Official Agenda for the March 21, 2017
Regular Town Council Meeting called for 6:30 P.M.

TOWN OF GOLDEN BEACH COMMUNITY DEVELOPMENT MEMORANDUM

Zoning Variance Applications

255 Ocean Boulevard Lots 34 & 35 in Block A

VARIANCE REQUEST 1: FIRST FLOOR ELEVATION +25.00' NGVD

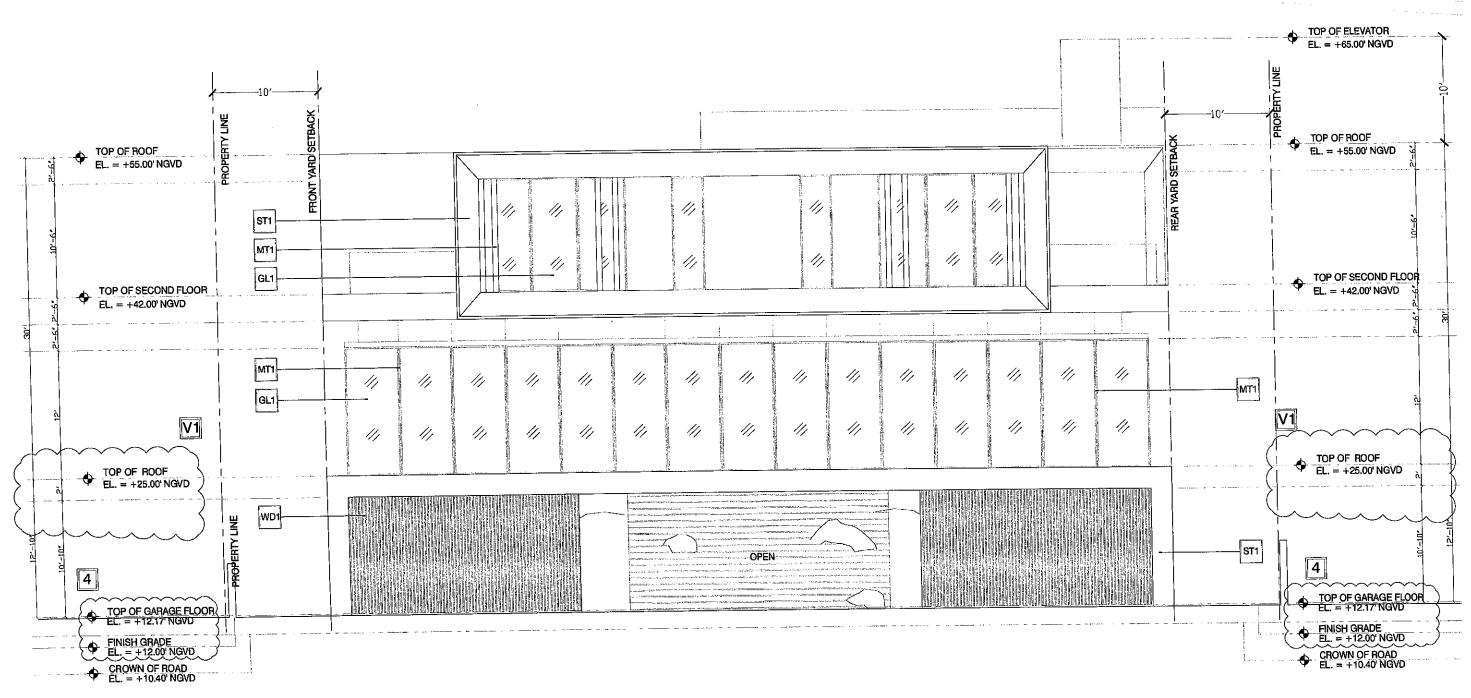
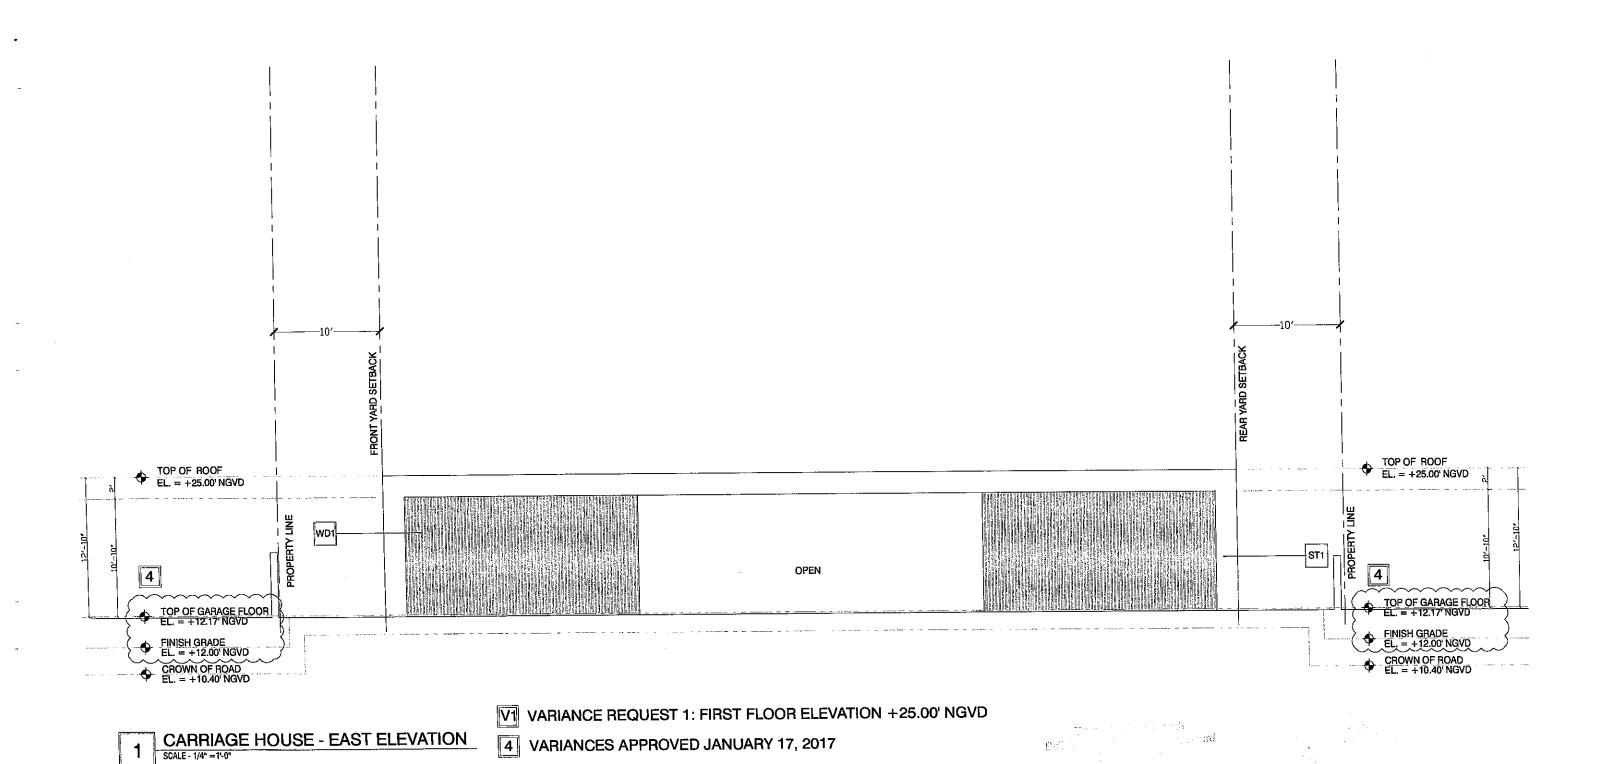
- Per Sec. 66-101(a)(1), the first-floor elevation may be no more than 2-feet above the FDEP requirements of 18.2' NGVD for Miami-Dade County east of the CCCL line. The plans show 25.0' NGVD (20.2' NGVD max). If the requested variance is not granted, the plans will need to be revised to comply with the Town Code. Additionally, MMPA notes that Town administration has stated it will not support a variance request to raise the first habitable floor slab to allow for a non-habitable space below that is greater than 8-feet.

MMPA notes that the plans show a structure height of 30.0' above the requested 25.0' first
habitable finished floor. The Town administration / MMPA will not support the variance
request, if the building height is increased above the normal allowance (20.2' NGVD plus 30.0').
